**Maine Bureau of General Services
Office of Chief Medical Examiner
Augusta, ME**

**e4h Project No. 2020090
Addendum No. 4**

This Addendum forms a part of the construction documents and modifies the original Issued for Bid dated July 14, 2023. The enclosed additions, deletions, corrections, and changes will be as binding as if incorporated in the original documents.

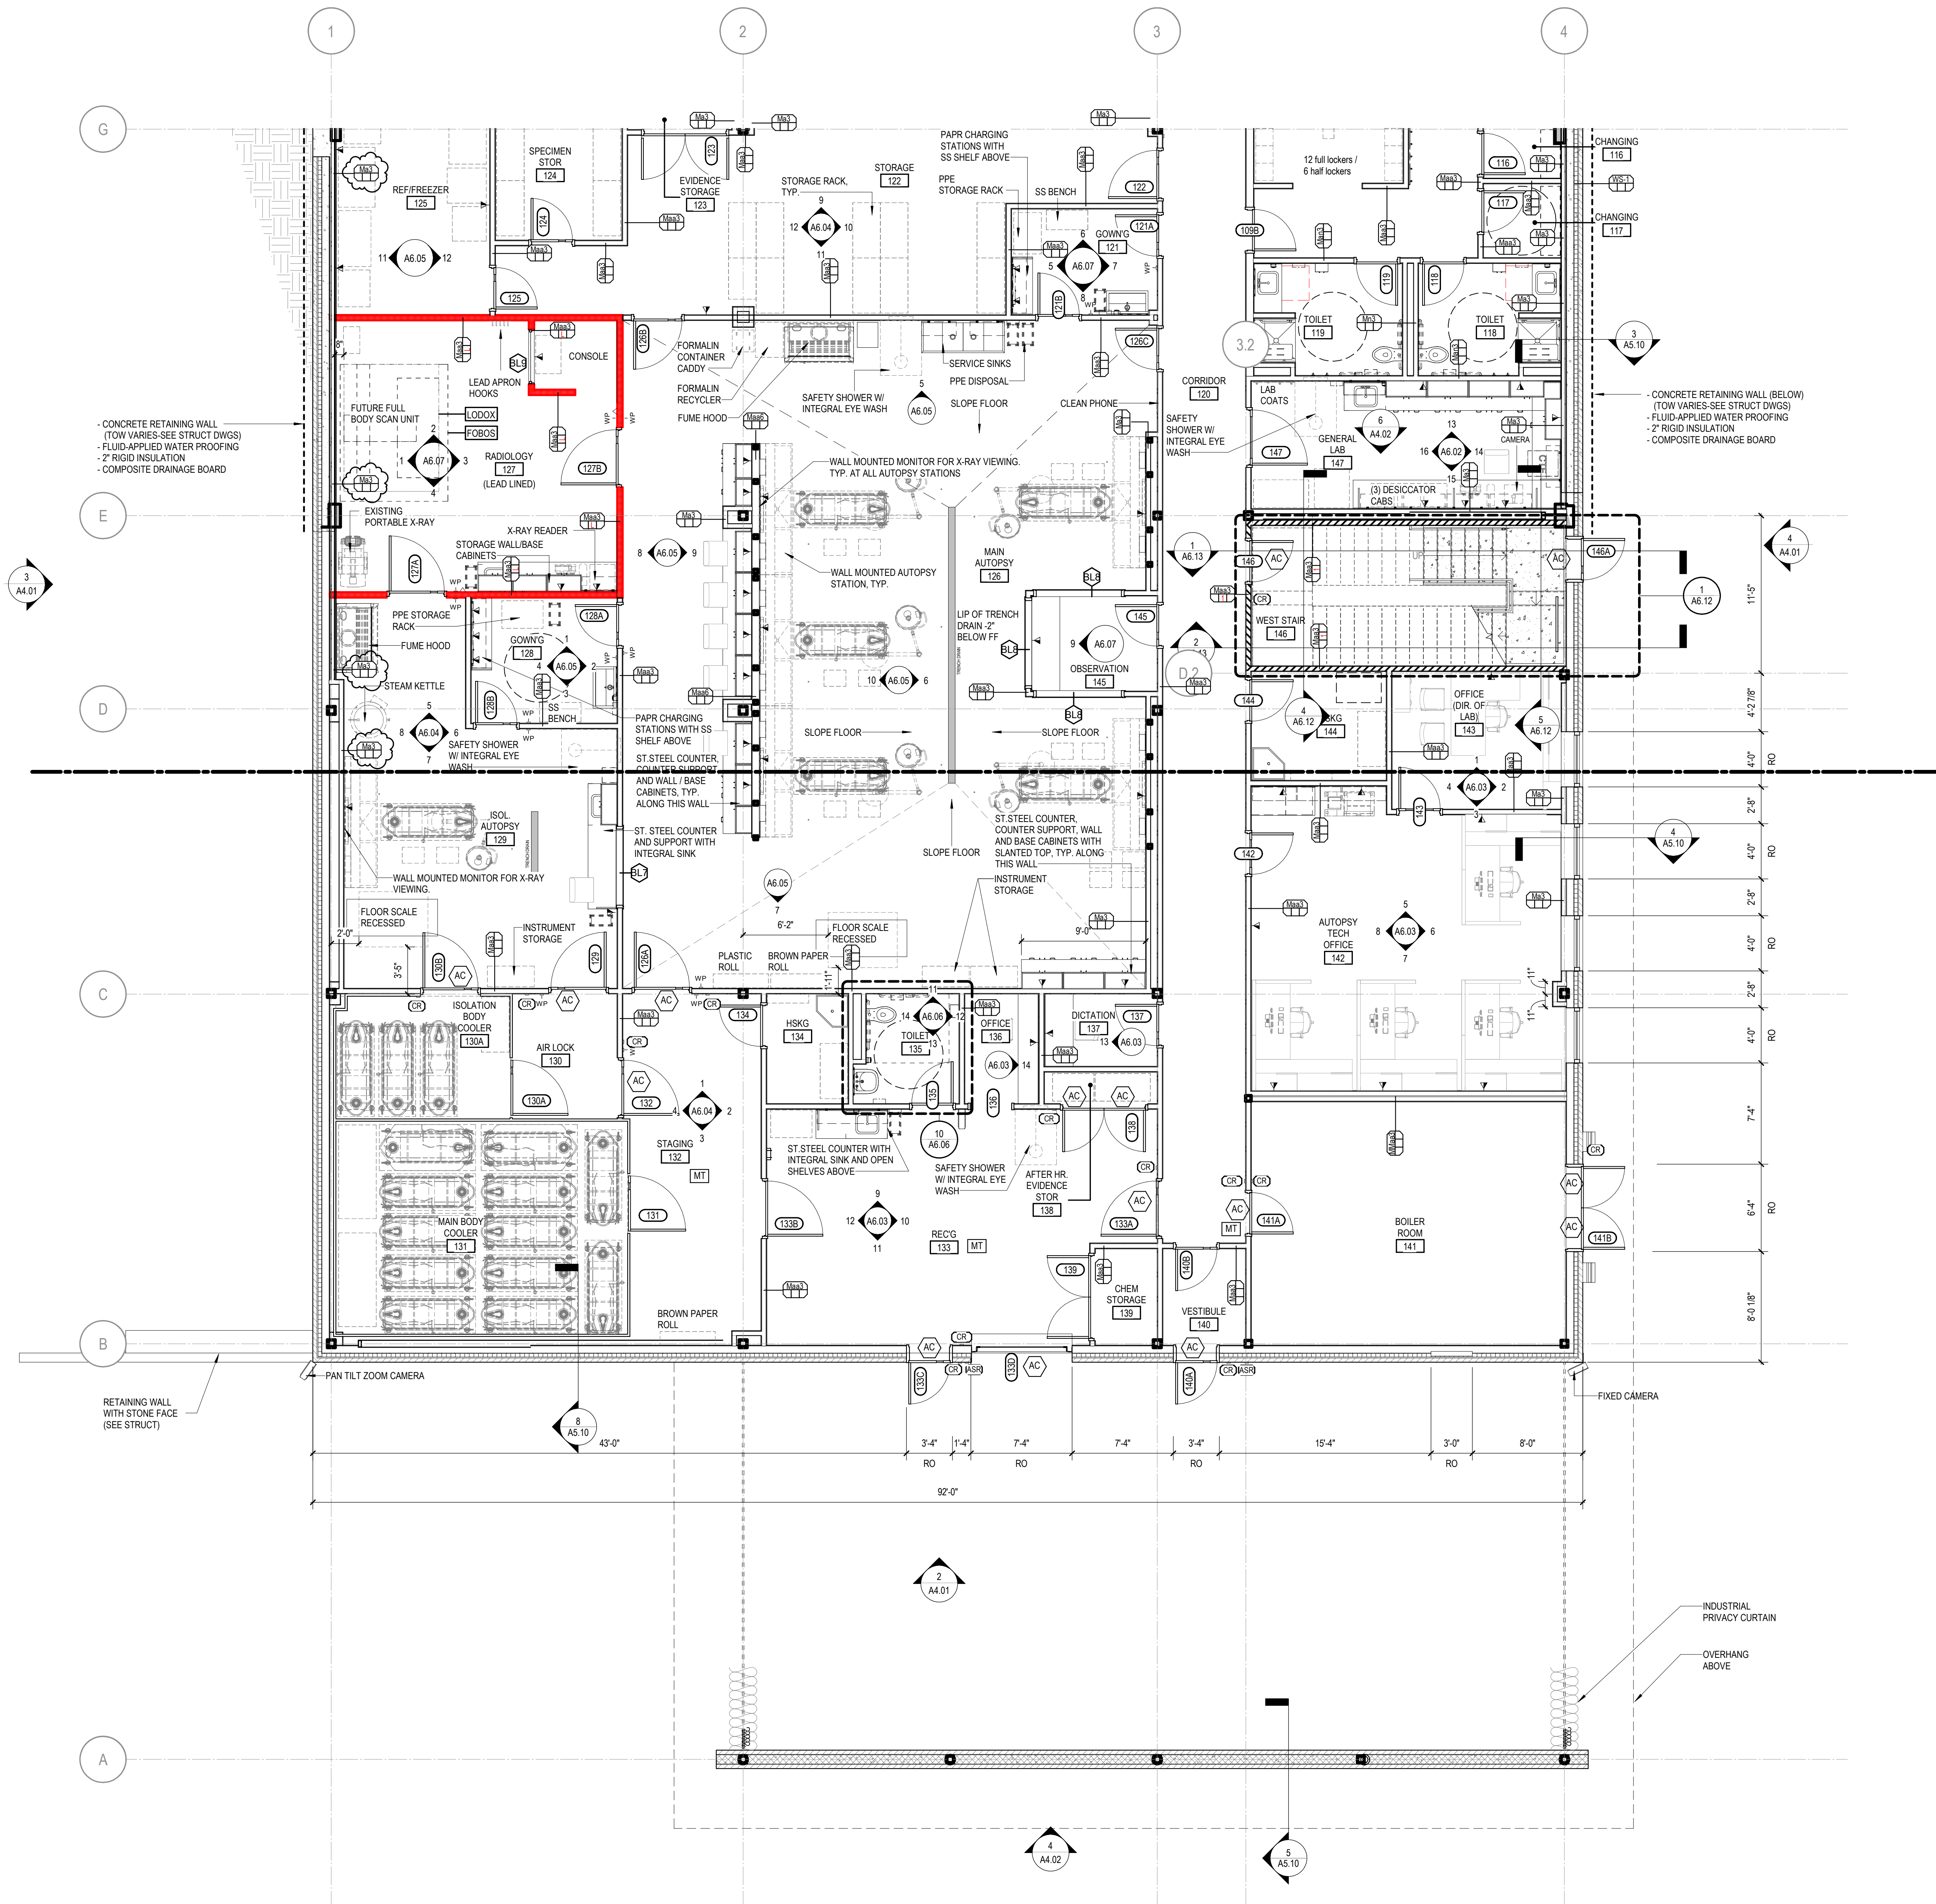
33. X-Ray Room - Lead-backed drywall or lead panels?
- a. **Refer to Specification Section 134900 – Radiation Protection**
34. Exterior Walls w/ no markings (e.g. electrical rooms) - any framing/drywall or just CMU?

- a. **See update drawing A1.10A & A1.10B for additional partition types along exterior wall**
35. Stairwells - Any framing and/or drywall in there
- a. **Yes, See A6.11 and A6.12 for wall types. East Stair, Second floor wall furring and gypsum should extend to stair exterior stringer below.**
